Subject: Transmittal of "Port of Stockton Municipal Separate Storm Sewer Audit Report"

Port of Stockton Municipal Separate Storm Sewer System (MS4) Audit Report

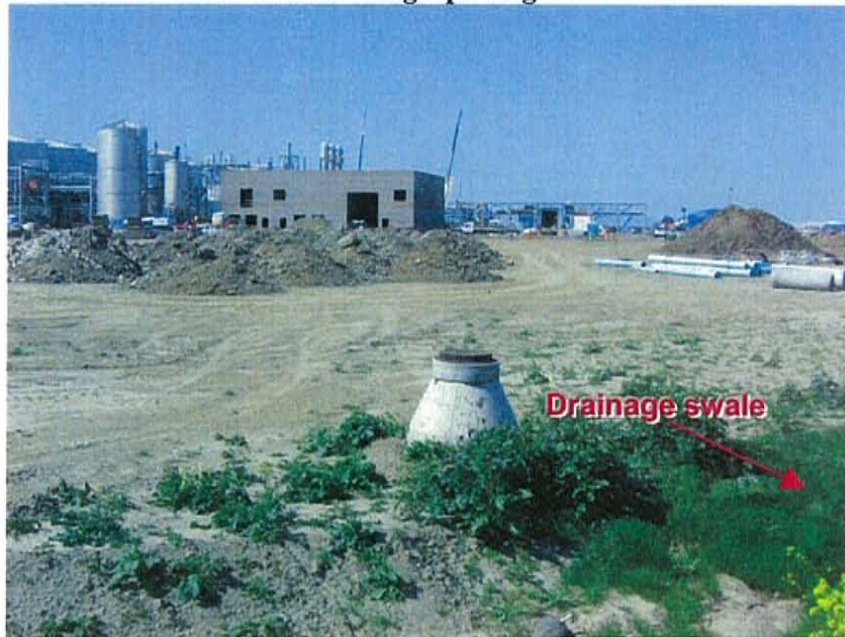
Photograph 1: An actively disturbed slope located adjacent to a drainage ditch along Navy Drive and southeast of the construction site entrance.

Photograph 2: BMPs were not implemented between the slope and the adjacent drainage channel or in the disturbed drainage channel itself, and the surface of the slope was not stabilized.

sediments generated at the Pacific Ethanol project site are retained on-site and that erosion from slopes and channels is controlled by implementing an effective combination of erosion and sediment control BMPs.

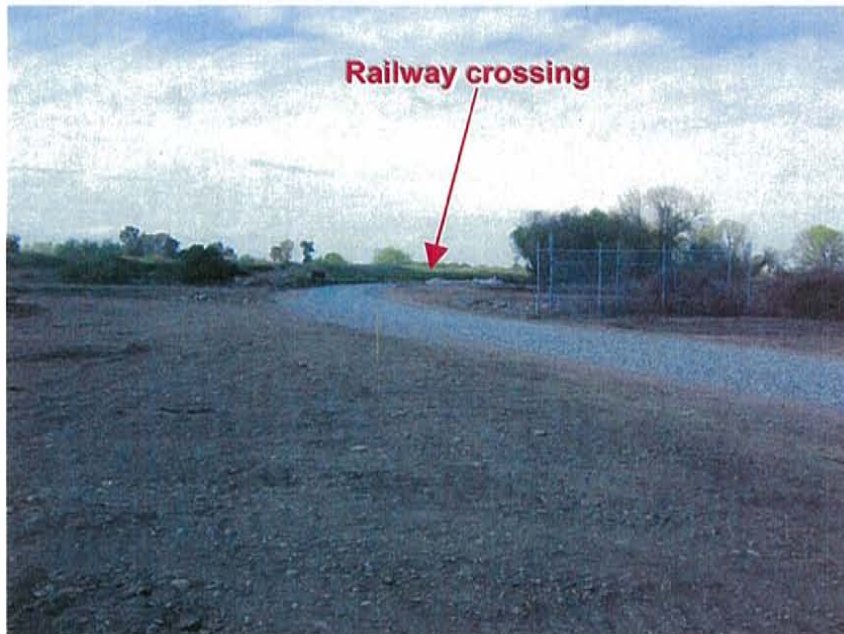
Photograph 3: BMPs were not implemented between a large expanse of disturbed soils, a number of uncontrolled soil stockpiles, and the adjacent drainage swale.

Photograph 4: Evidence of erosion was observed; including rill formation on the slope of the drainage swale.

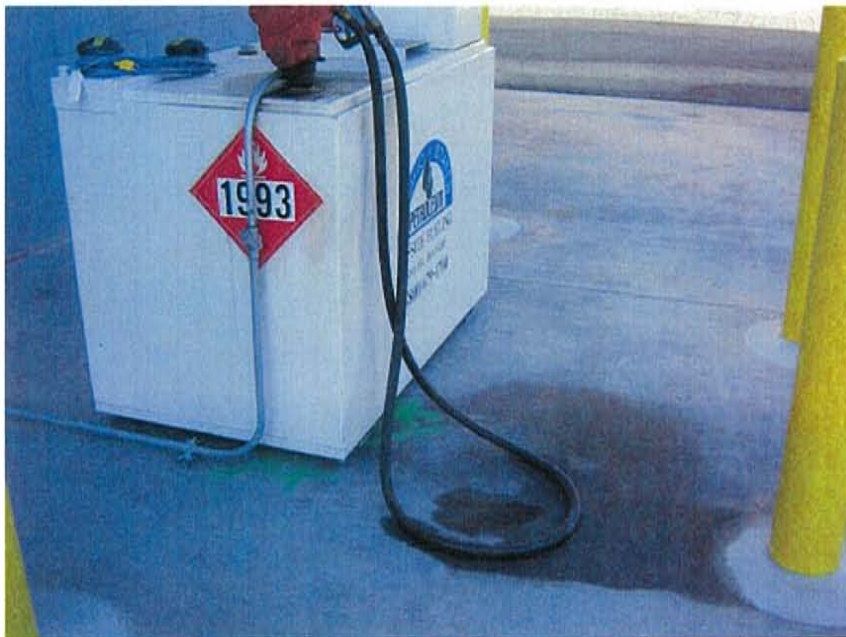
Photograph 11: View of Lowe's Distribution Center equipment maintenance shop.

Photograph 12: View of Lowe's Distribution Center fuel storage tank located adjacent to the maintenance shop.
